From: [Participate](#)
To: [Heather Nicolai](#)
Subject: FW: 219 Hillside CUP application
Date: Friday, July 7, 2023 11:53:06 AM
Attachments: [salesofficecopier@mossgreenhouses.com_20100403_105012.pdf](#)

From: Kevin Moss <kevin@mossgreenhouses.com>
Sent: Friday, July 7, 2023 9:35 AM
To: Participate <participate@ketchumidaho.org>
Subject: 219 Hillside CUP application

From:
Kevin and Dana Moss
215 Hillside Drive
Ketchum

We respectfully request that the P&Z board deny the approval of a Conditional Use Permit for the 219 Hillside property. The Title 17 Zoning Regulations as shown in the attachments states, Chapter 17.92, D., (2.). These rules do not allow deflection of avalanches toward the property of others.

ORIGINAL (CURRENT)

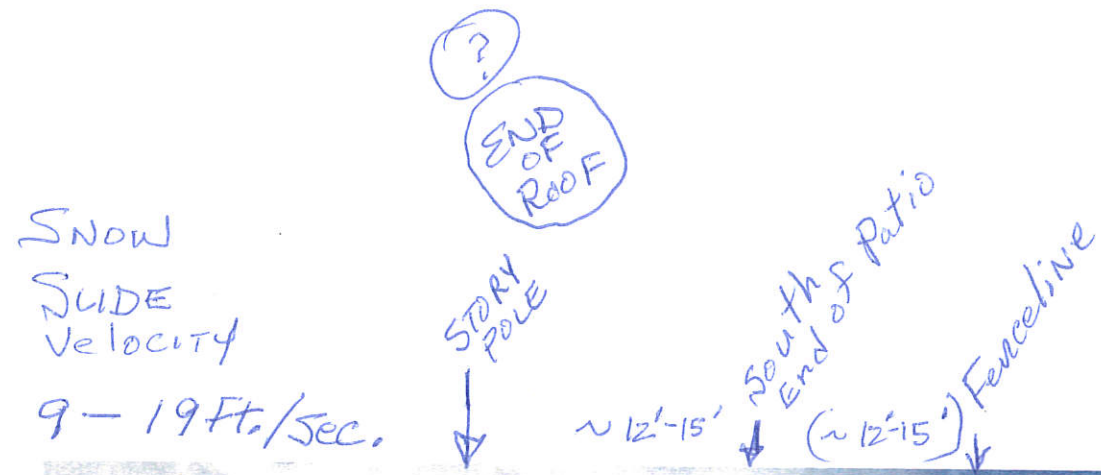
AVALANCHE

Snow Depth ~3-6ft.

Avalanche  SLOPED &
FORCES  HORIZONTAL

AVALANCHE WITH New Structure @ 219 Hillside

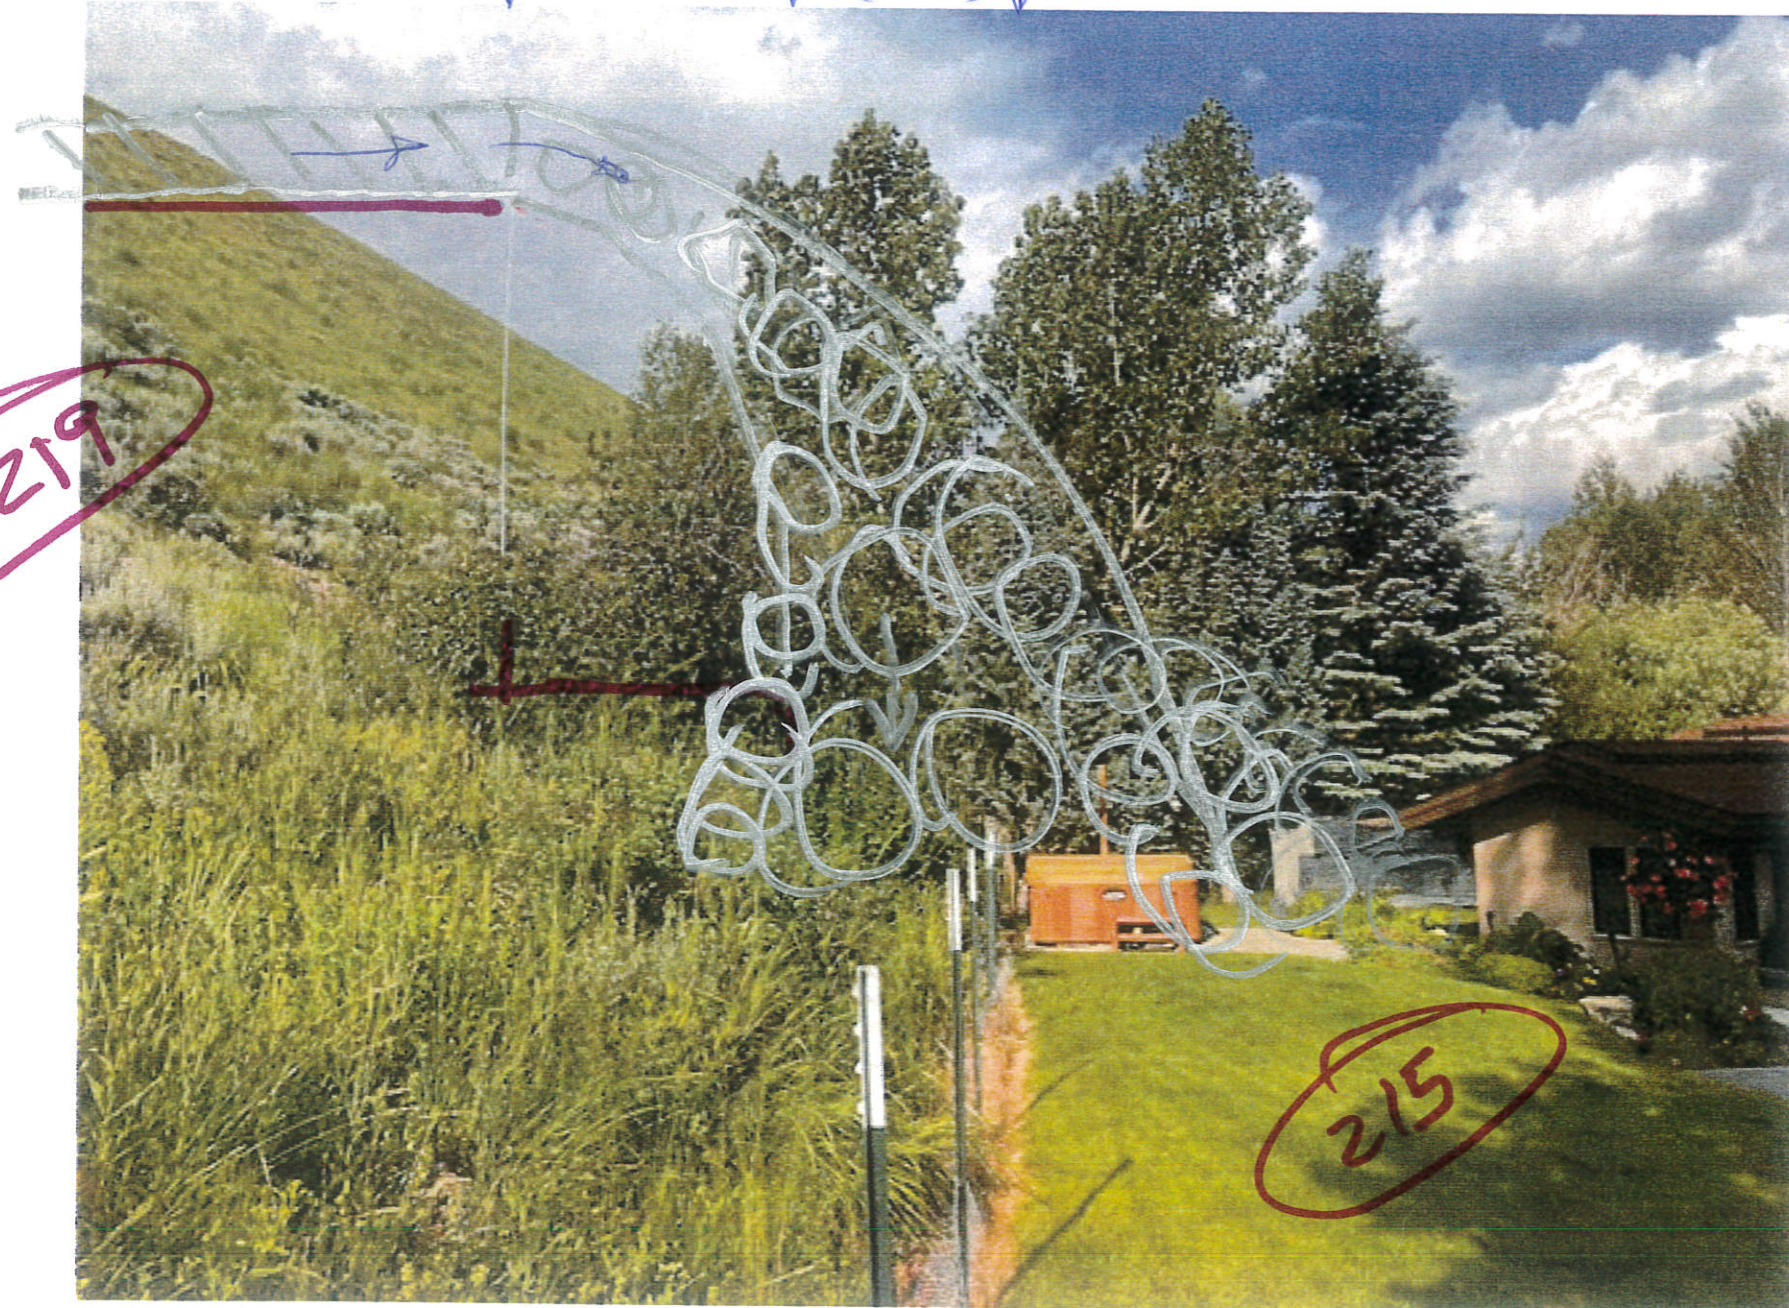
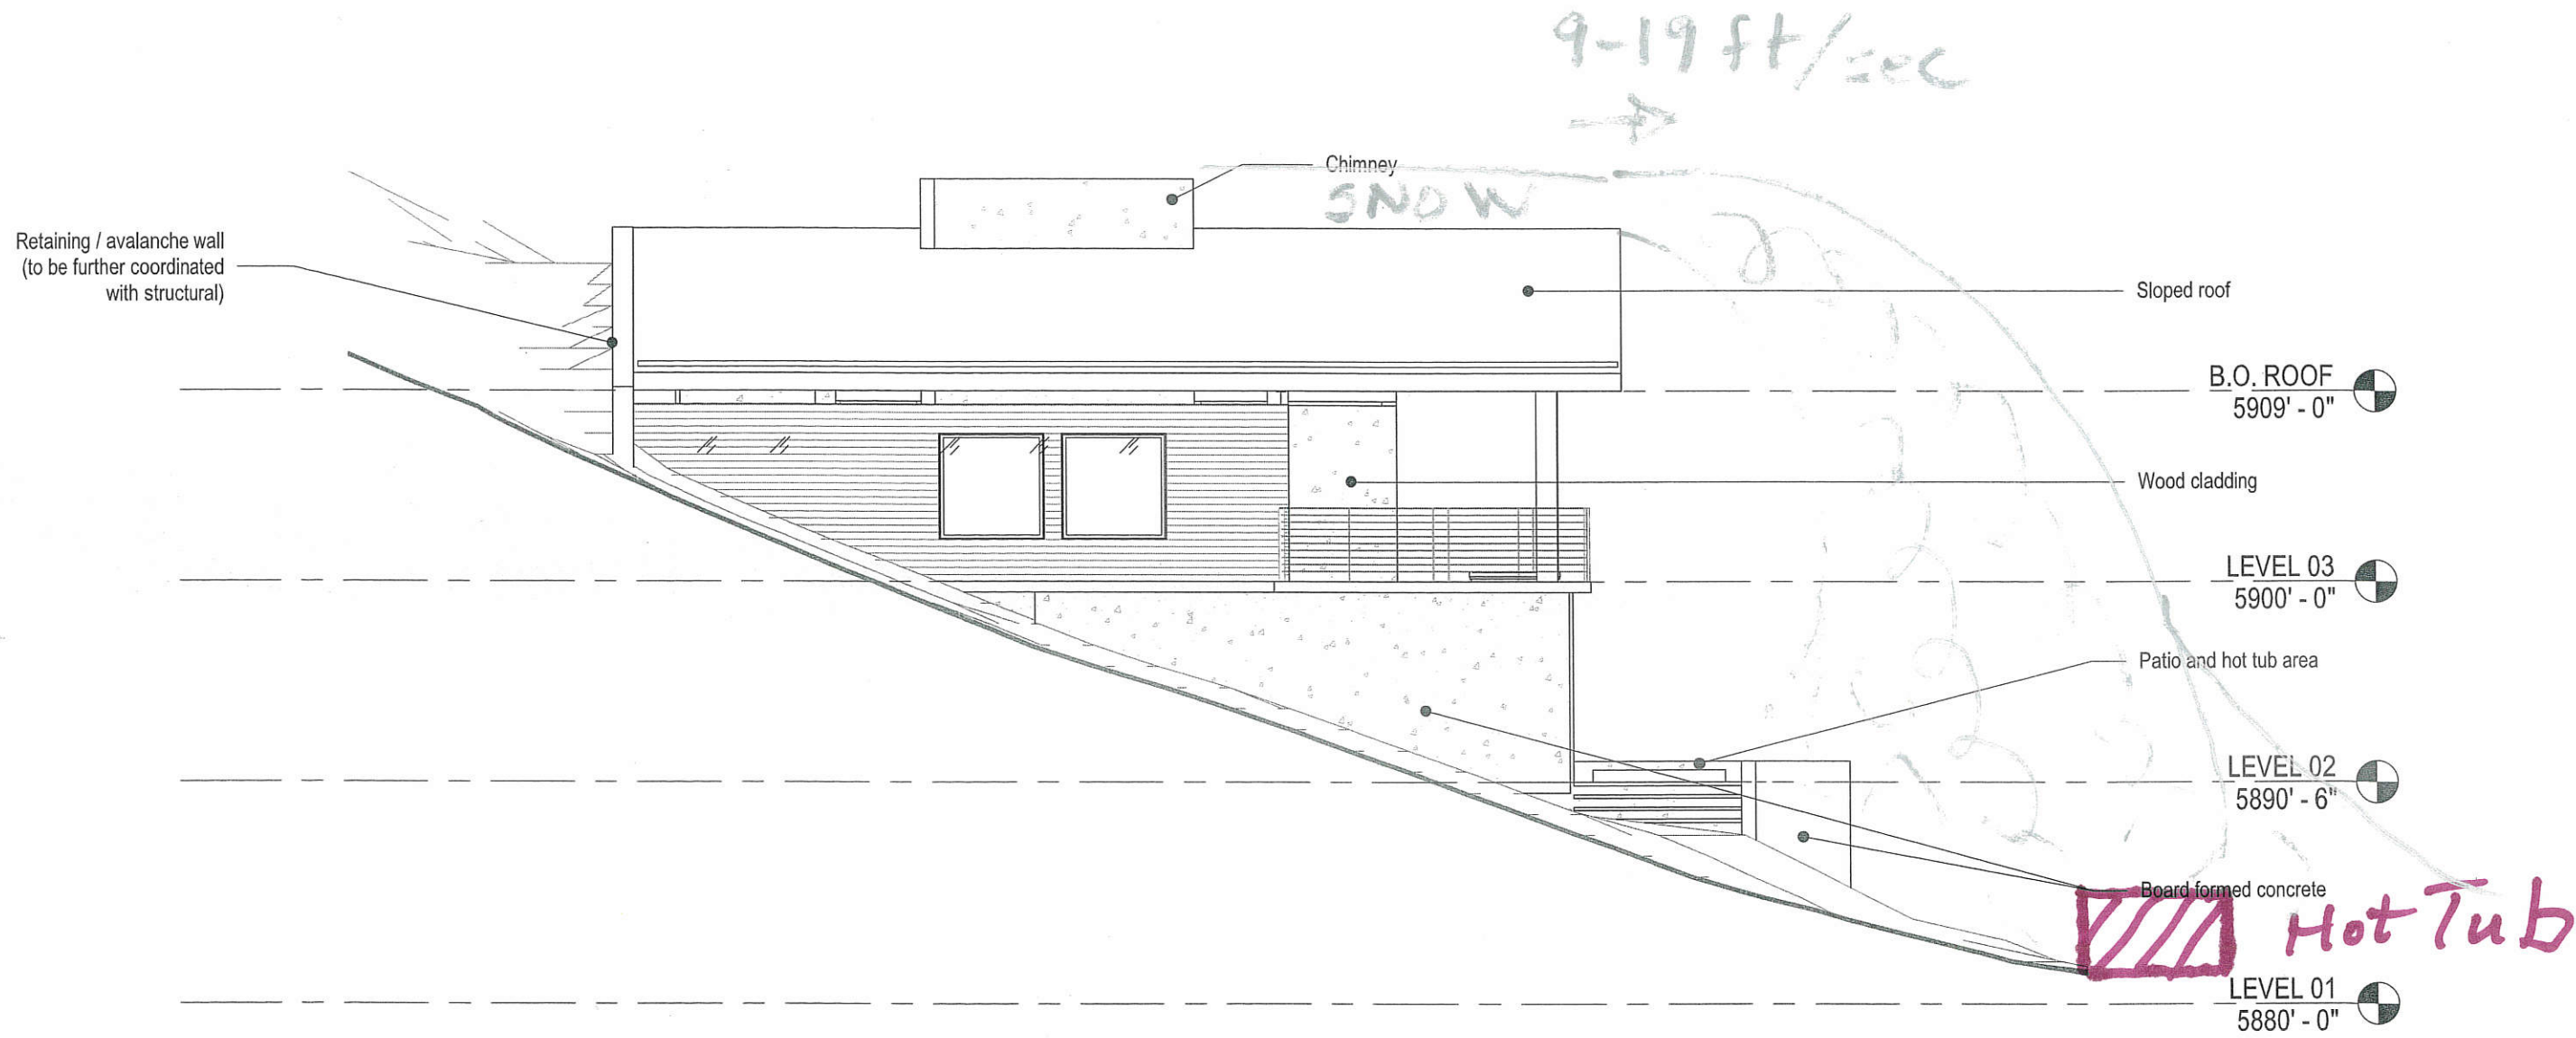
↓
AVALANCHE FORCES ↓ VERTICAL
SNOW DEPTH ~ 3-6 ft deep

All Avalanche Forces, directions and dynamics will be Altered, due to this designed structure above 215 Hillside.
